FCC Advisory Committee on Advanced Television Service

APPENDIX VIII

Subject: Change/Modifications to ATTC Test Procedures.

Fig 1 1-10-91

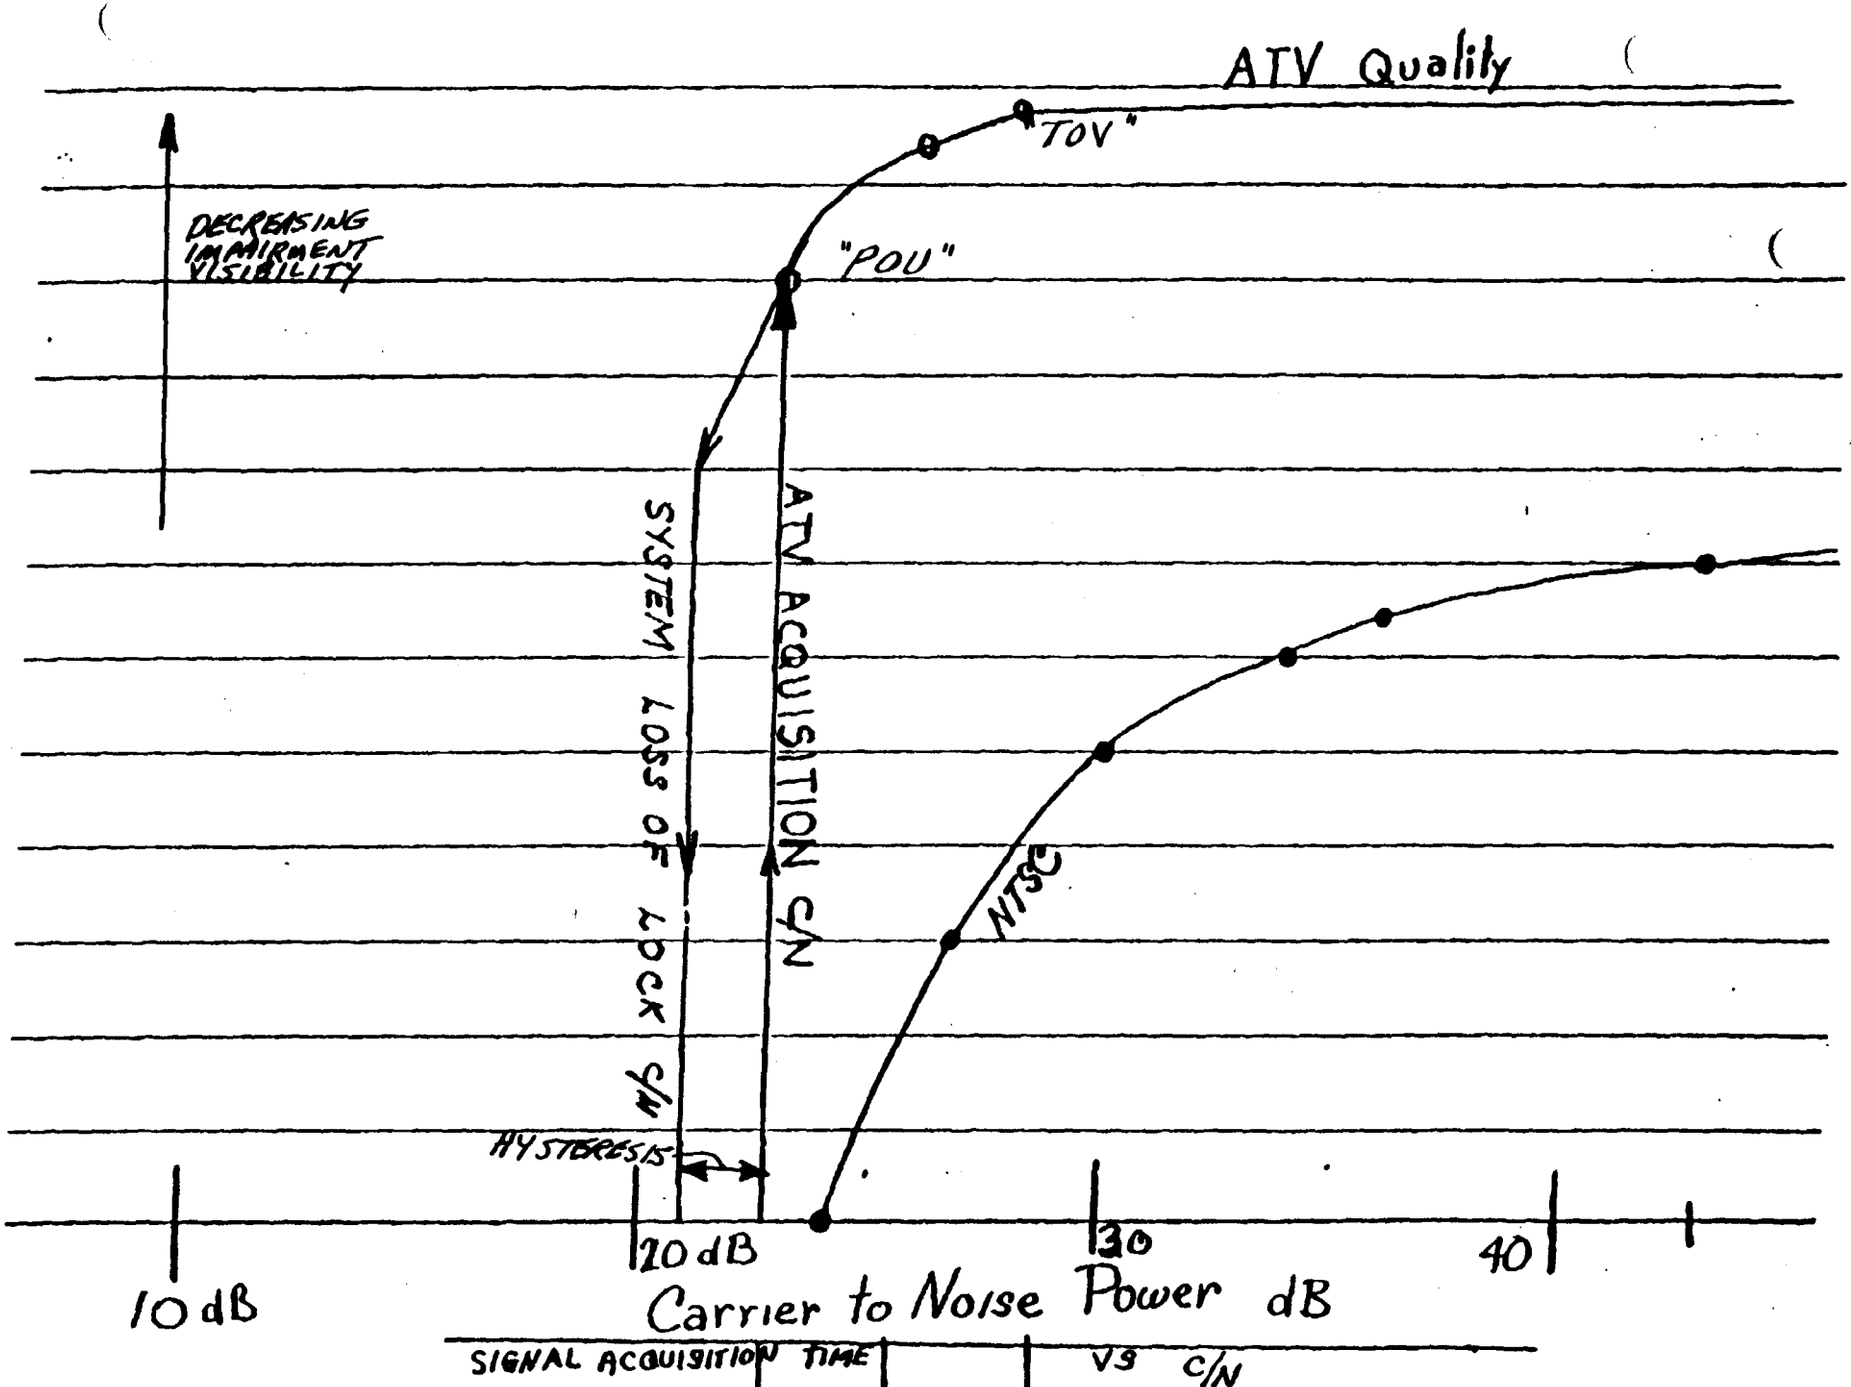
Digital TV systems are expected to exhibit hysteresis between the C/N at which the receiver can acquire (synchronize to) the signal and a lower value of C/N below which reception ceases (loss of synchronization). The difference between these two C/N levels is the noise hysteresis of the system.

We recommend that the procedure of Section 19.2.3 be amended to specify that, in the event hysteresis is found, the higher of the two levels (i.e., the level corresponding to signal acquisition) be reported as the "Weak" signal level. The magnitude of the hysteresis also should be reported for the record. The hysteresis is of interest since, once the receiver has acquired a weak desired signal, the level of that desired signal may fade.

Hysteresis is also a factor in procedures that involve expert determination of Threshold of Visibility (TOV) and Point of Unusability (POU). In particular, it is important that the POU be approached from a level of impairment sufficiently high that the receiver cannot acquire the signal. Then, the reported POU would be the level at which acquisition first occurs, provided that the experts deem the reception "usable" at that level. Otherwise, the POU would be the slightly lower impairment level at which reception just becomes usable. The TOV would be the level beyond which no further improvement in reception occurs as the impairment level is decreased. If the reported TOV and POU are converged upon iteratively, approaching them alternately from each direction, then care must be taken that the reported levels are within the range between the acquisition threshold and the level at which no further improvement in reception occurs (i.e., that the reported levels are not between the acquisition threshold and the level at which there is loss of lock).

SS/WP-2, the testing laboratory will exercise its discretion as to waiting time for acquisition. Inasmuch as the acquisition threshold is equivalent to the POU, as explained in an earlier paragraph, we recommend that the procedure for finding POU for a digital system having hysteresis be as follows:

> Begin with the undesired signal at a level too high for acquisition to occur (the "starting" level for this procedure). Switch the attenuator to the first undesired level to be tried. Wait for a predetermined time. At the end of this time, the expert observers declare whether acquisition has occurred. If not, then return the attenuator to the starting level. Then switch the attenuator to the next level to be tried. Continue until the level is reached at which the experts observe that acquisition occurs within the allowed time. This level is the reported acquisition level.

Figure 1: Proposed Test Picture

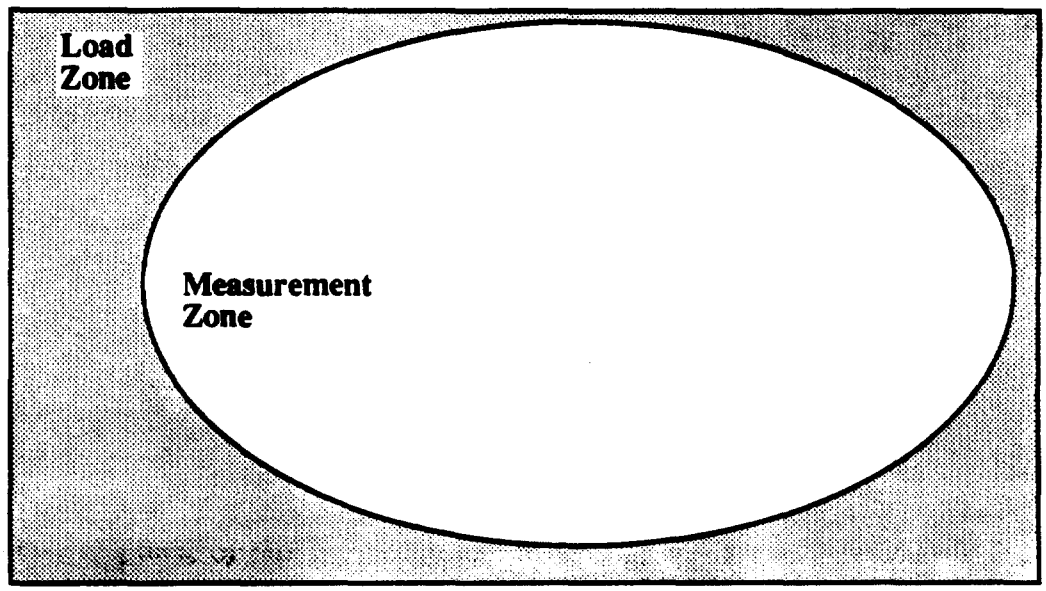
Figure 1 illustrates the general appearance of the test picture proposed by ATRC to be used in the Resolution and the Transient Response test procedures. There are two basic components in the test picture: (1) the circularly-shaped area called the *measurement zone* and (2) the background area called the *load zone*.

The purpose of the *load zone* is to provide sufficient load to the video compression system so that the tests and measurements taken within the *measurement zone* are indicative of the performance of the SUT under realistic conditions.

The ratio of the areas occupied by the two zones, hereafter called the *load-to-measurement ratio*, and the location of the *measurement zone*, provide further test controls. By choosing different load-to-measurement ratios, the system is subjected to different levels of stress. The associated measurements are therefore indicative of the potentially different performance of the SUT under different operating modes/states. For example, a load-to-measurement ratio of 1:10 may be a light load, while a 10:1 may represent an extremely stressful load on the SUT.

The *load zone* shall contain white (Gaussian) noise of a specified variance. The variance, or equivalently the noise power, should be sufficiently high that the noise causes desirable loading of the SUT. Because of the sophisticated motion algorithms that are likely to be used in a digital ATV system, it is important that the noise vary in both the spatial and the temporal directions, i.e., a "moving" white noise pattern rather than a fixed (albeit random) noise pattern. The picture within the *measurement zone* shall be the test picture described in [1] for the Image Resolution and the Transient Response measurements.

Figure 2: Proposed Test Picture for Image Resolution Measurement.

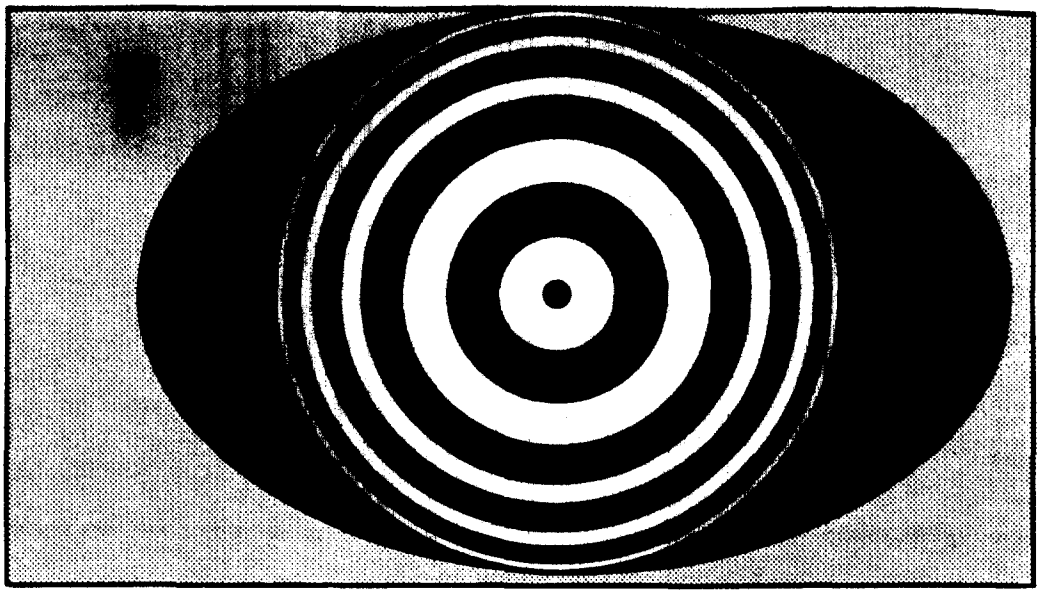
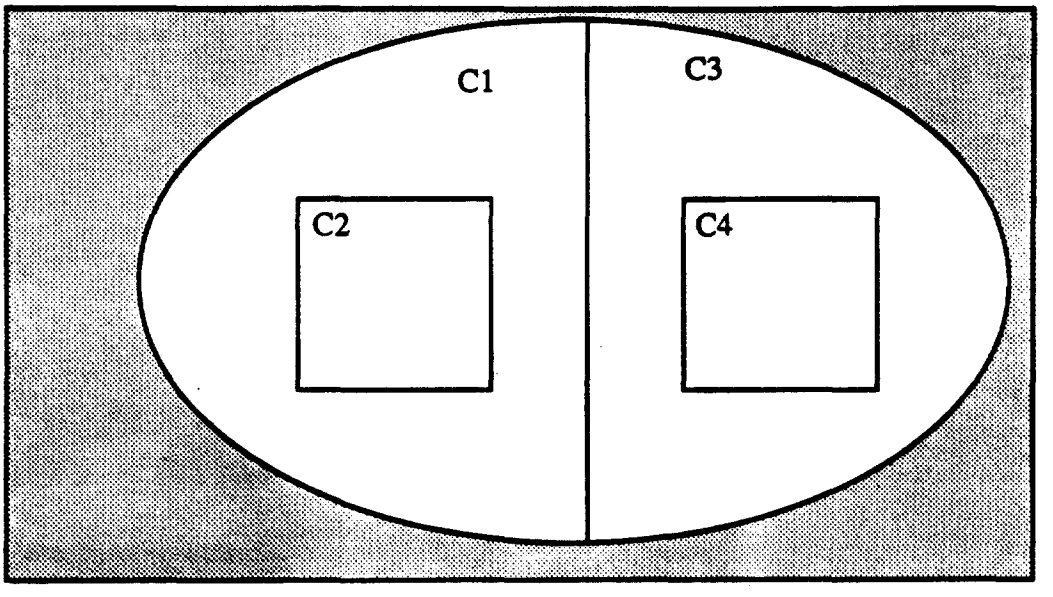
Figure 2 shows the proposed test picture for the Image Resolution tests. The *measurement zone* depicts a circular zone plate as shown in Figure 1-1 of the WP2 document [1]. Figure 3 shows the proposed test scene for the horizontal and vertical transient response tests. The areas marked C1, C2, C3, and C4 correspond to the same areas in Figure 3-2 of [1]. For the measurement of the temporal transient response, Figure 4 shows the test picture after the Radial Resolution Test Pattern (Figure 3-3 of [1]) has been gated into the *measurement zone*. The test picture before the test pattern has been gated in would have a flat field for the *measurement zone*.

Figure 5: Alternative Load and Measurement Zone Arrangement.

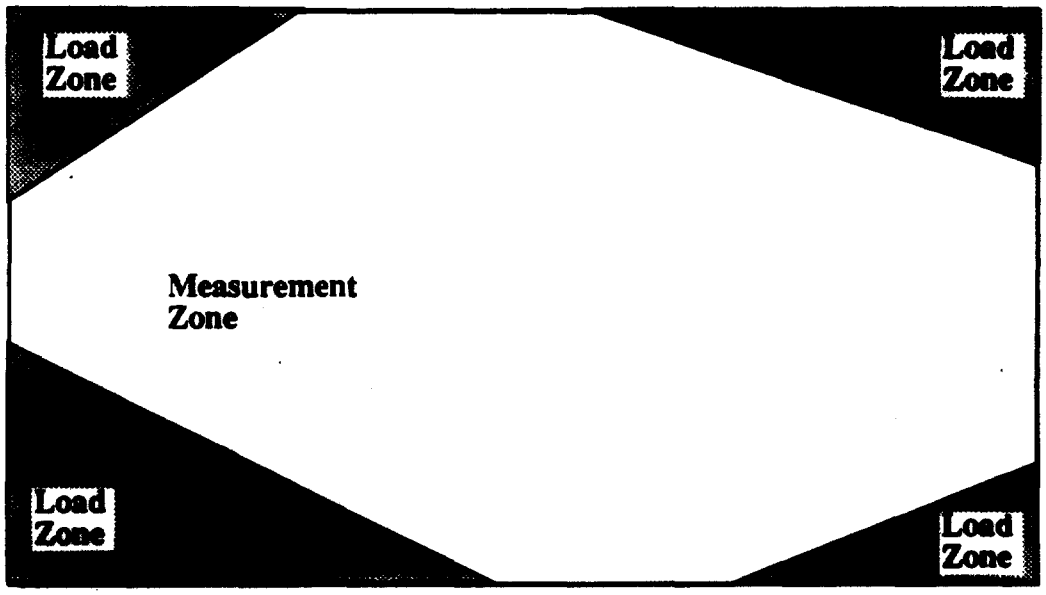
To allow the maximum spatial frequency of the test patterns (circular zone plate or the radial resolution chart) to be in the *measurement zone*, it may be necessary to shift the center of the test pattern away from the center of the *measurement zone*. Alternative arrangement of the two zones in a test picture can be used. An example of an alternative arrangement is shown in Figure 5. The *load zone* covers the four corners of the picture, while the remaining area is used for the *measurement zone*. The arrangement of the four *load zones* can be selected such any desired resolution on the circular zone plate is depicted within the *measurement zone*. It is desirable that the shape of the *measurement zone* be non-rectangular to avoid the event that the zone border(s) may coincide with any block structure that is introduced by the video compression system. Toward that end, a circular *measurement zone* is desirable.
